Recall Campaign Bulletin

Campaign No. 2024120005, January 2025

SUBJECT: **Model GLC and S-Class (254 and 223 platform)**
Model Year 2024

Correct Bolting of Rear Axle Differential

Figure 1

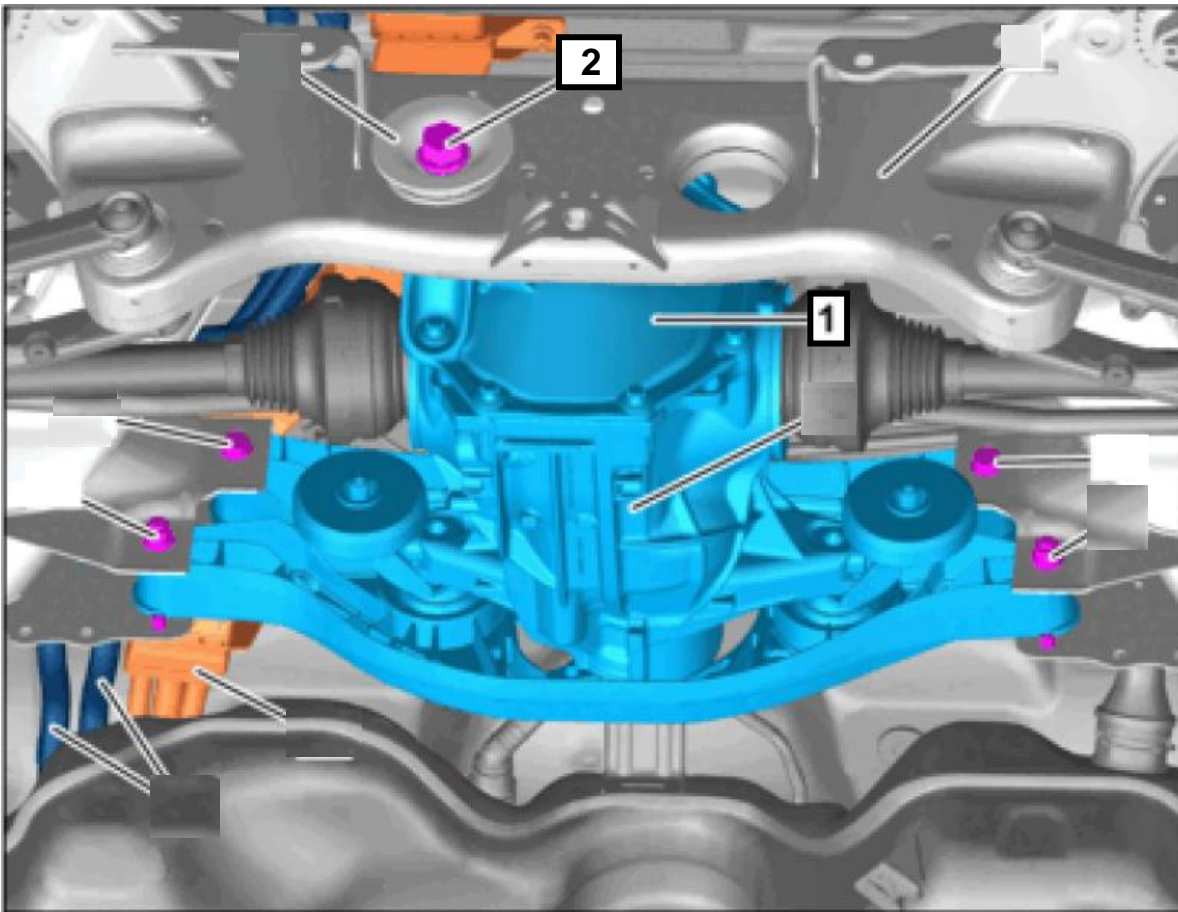
1. Replace rear axle differential end cover (**Figure 1, 1**).

i The rear axle differential **screw** to the rear cross brace (**Figure 1, 2**) must always be **replaced**.

Nm Observe the specified tightening torque, see:
BA35.10-P-1005-01U (model 254)
BA35.10-P-1011-01R (model 223).
